Charlotte Department of Transportation

Memorandum

Subject: Rezoning Petition 15-062: Approximately 20.9 acres located at the intersection of NC Music Factory Boulevard and Hamilton Street generally surrounded by Interstate 77, West Brookshire Freeway, and Seaboard Coast Line Railroad
(Revised 5/18/15)

Figure 1

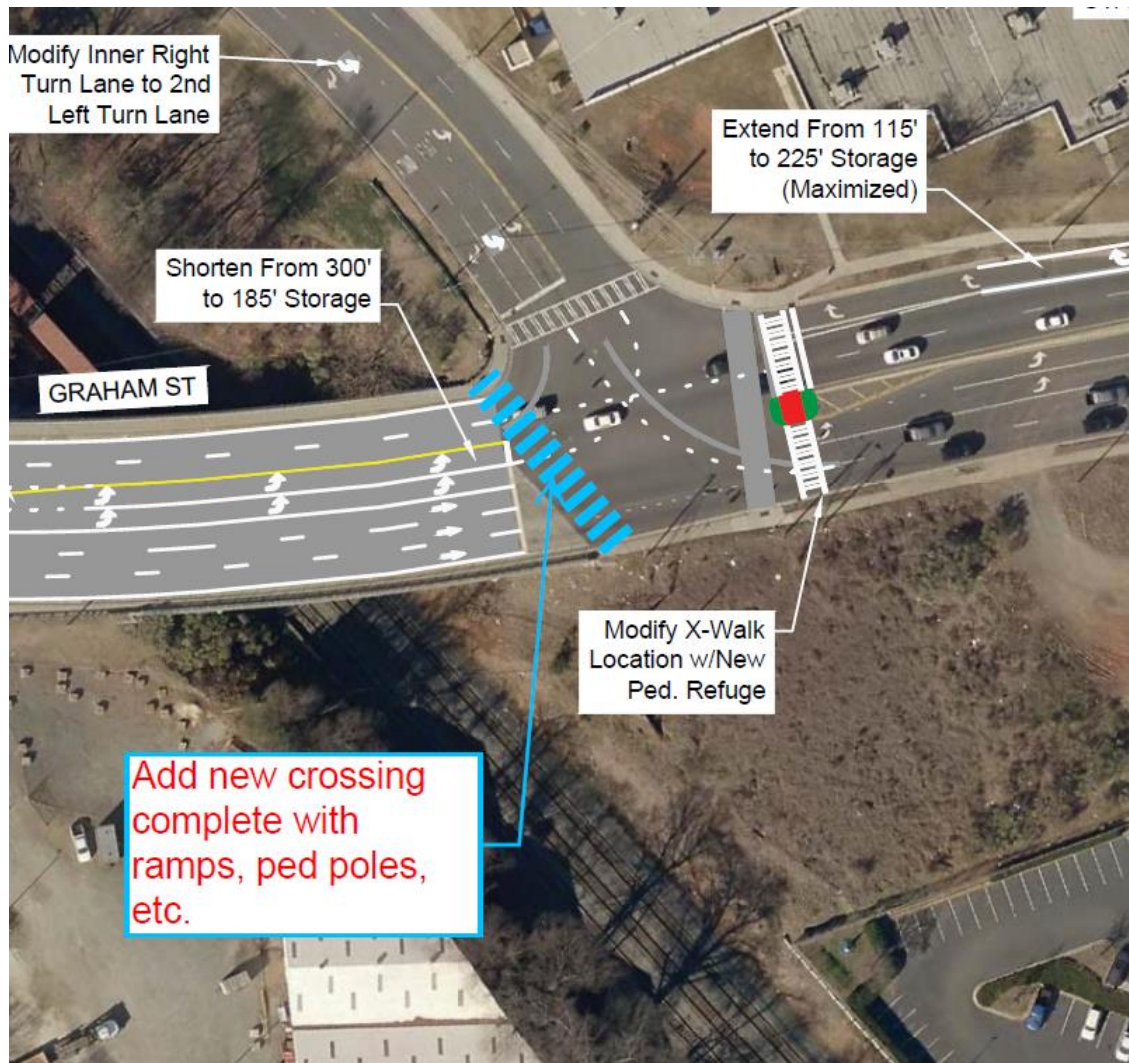
1. N Graham St and North Carolina Music Factory Blvd
 - a. CDOT agrees with the proposed traffic and pedestrian improvements at this intersection, with the exception of adding a crosswalk and ped poles to the NB N Graham approach. After further review CDOT staff requests a crossing be added at this location. See Figure 1. The only other reasonable mitigation would be to add the 2nd right turn. Given that adding the dual rights is of marginal benefit and would widen the intersection to make crossing more difficult for pedestrians, we do not recommend it at this time. Instead, we recommend additional pedestrian improvements at Study Intersection 3 and for the petitioner to contribute to an adjacent City project to add sidewalk from W 10th St to W 12th St.

Figure 2

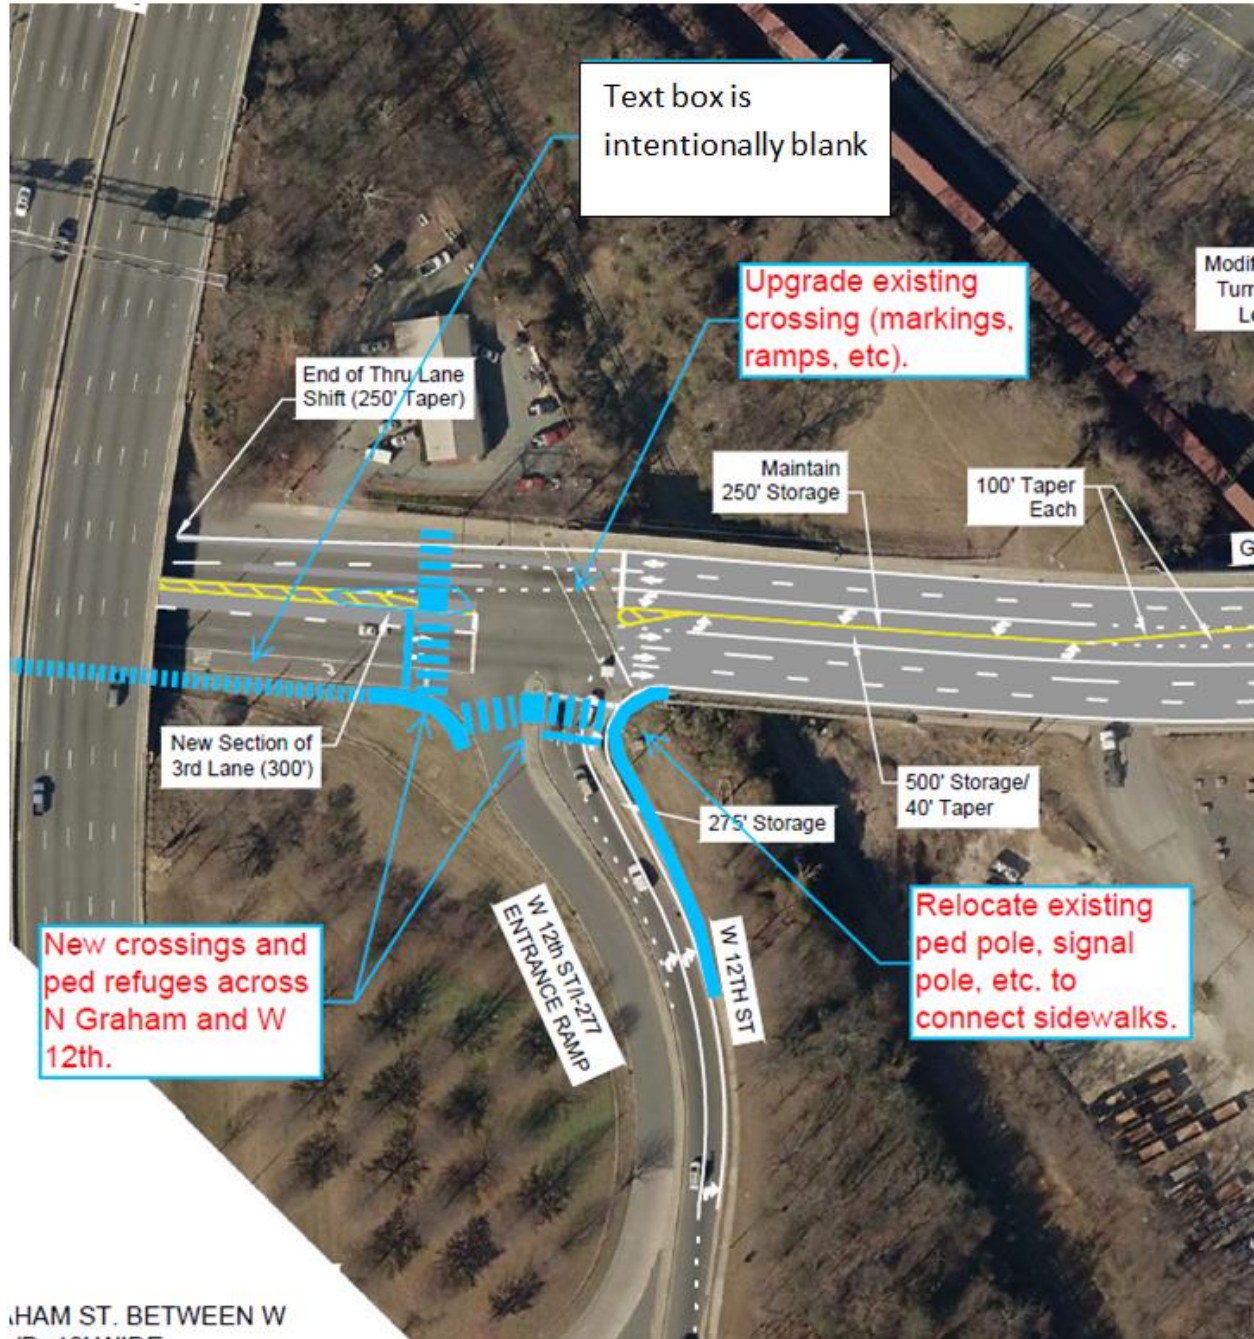
3. N Graham St and W 12th St.
 - a. CDOT agrees with the proposed mitigations except for the statement regarding pedestrian accommodations at this intersection. The only crossing that exists at this intersection is a skewed crossing located on the SB approach with no refuges. Thus, CDOT requests that the existing crossing be brought up to current standards and new crossings with pedestrian refuges be added. There will be signal pole relocation, ped

pole additions, and other incidental signal work as part of this project. See Figure 2 below for a conceptual plan.

Figure 3

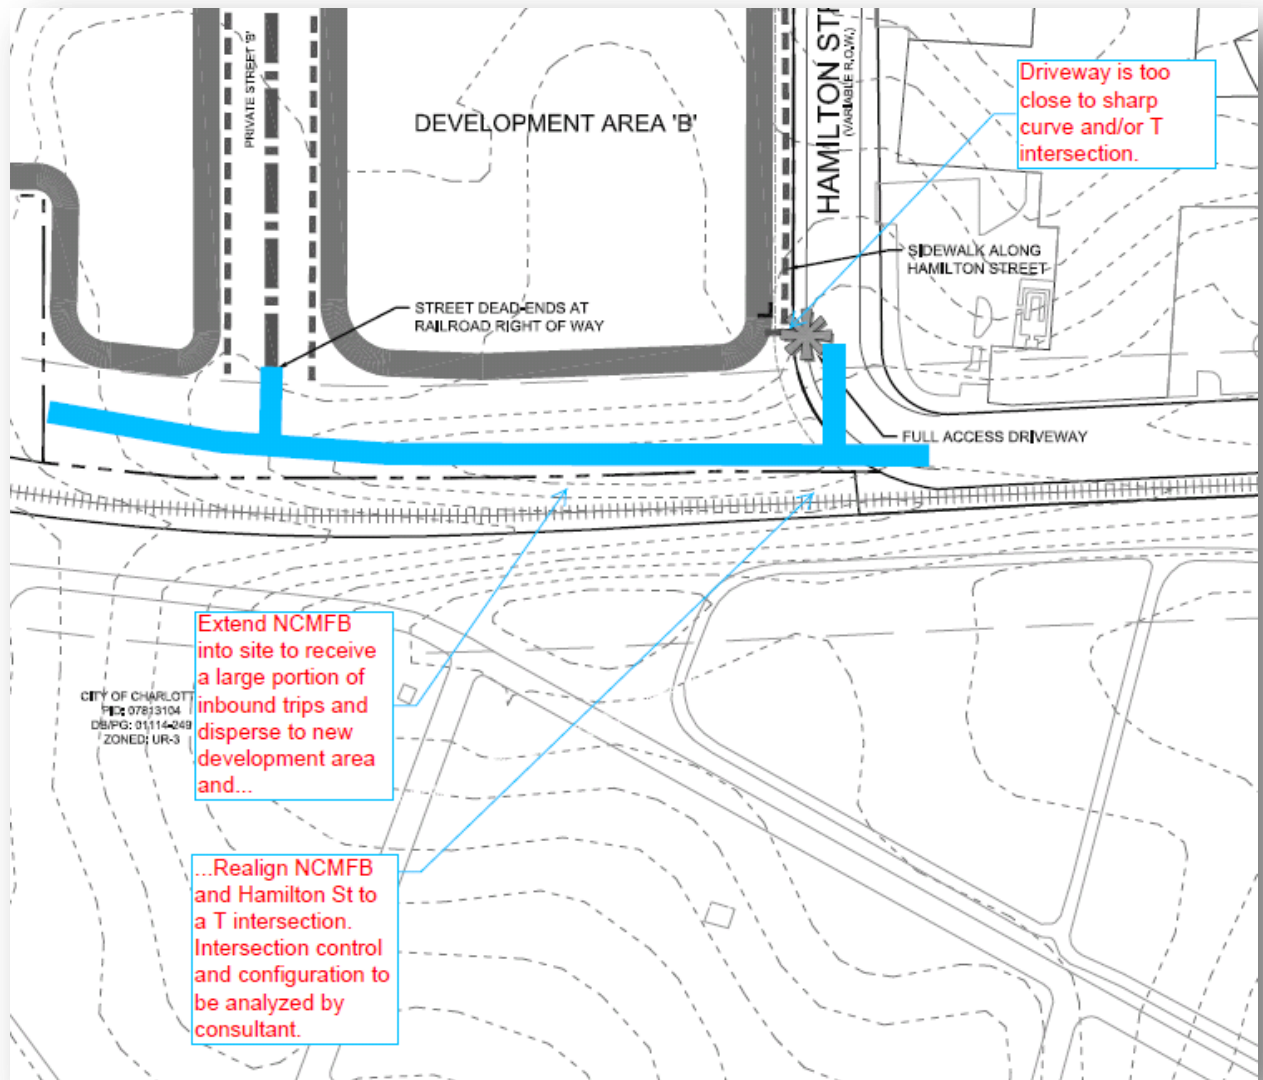
4. CDOT requests the petitioner investigate extending North Carolina Music Factory Boulevard (NCMFB) into the new development area to receive a large portion of vehicular

trips to the office and parking areas. By doing this, the intersection of NCMFB and Hamilton Street becomes realigned to a T-intersection configuration. The petitioner should analyze this T-intersection and make recommendations as to the appropriate traffic control device (e.g. stop signs or signal). See Figure 3 below.
